ADDENDUM NO. 2

DATE: 10/21/2014

TO: ALL BIDDERS
FROM: JKF ARCHITECTURE
RE: NCDOT Currituck Welcome Center
SCO ID #120956301; Code 84210; Item 7826
Project No. 2013-04

DRAWING A1.2 REVISION #1
 10-20-2014

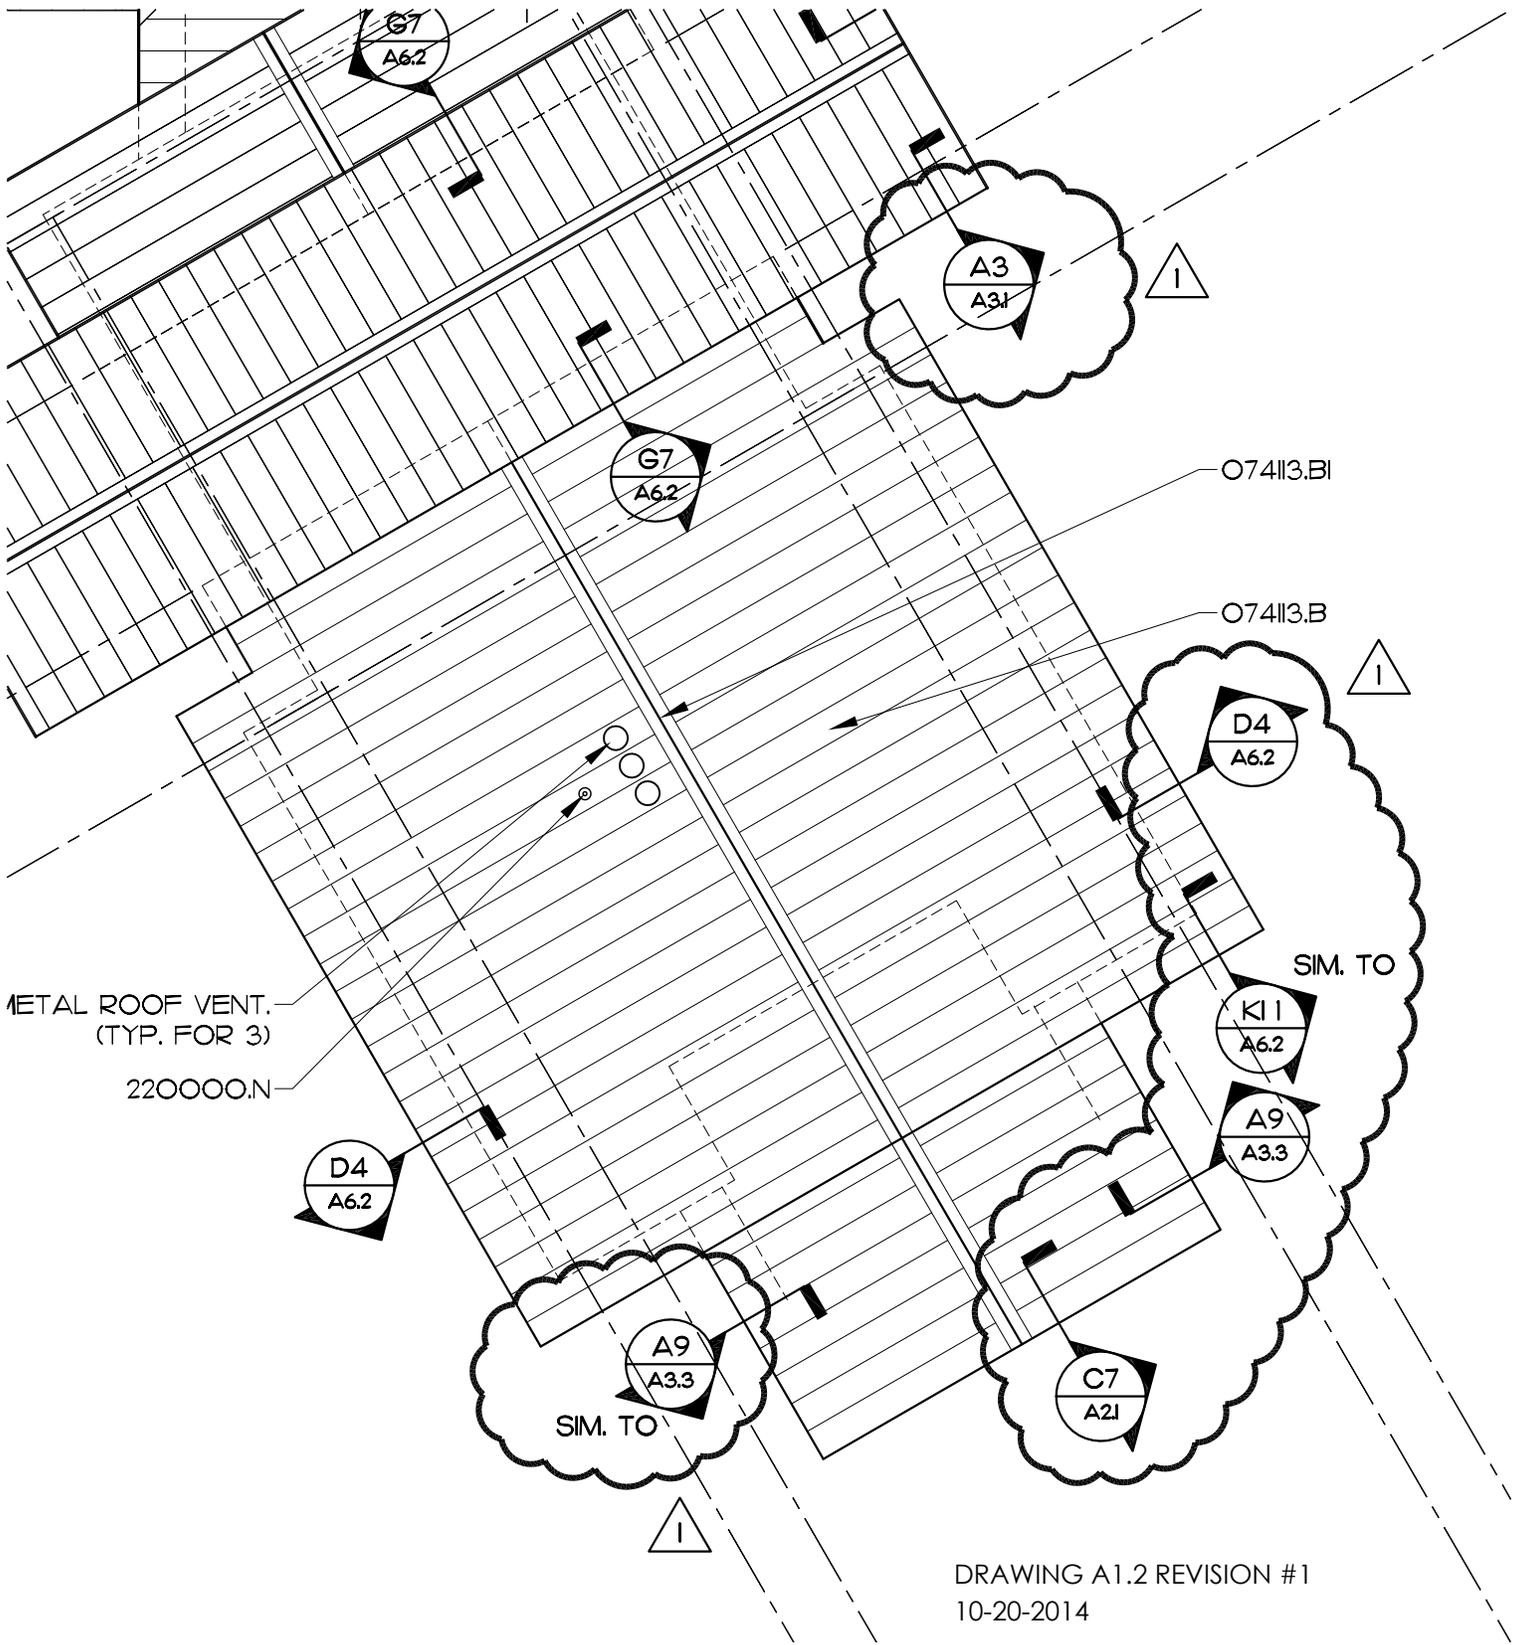
1. See attached Drawing A1.2 Revision #1, dated 10-20-2014 for minor clarifications to Section tags.

6. Bidder Question Re A1.2 – Some of the sections/details appear to be mis-labeled. **JKF RESPONSE: See attached Drawing A1.2 Revision #1, dated 10-20-2014 for minor clarifications to Section tags.**
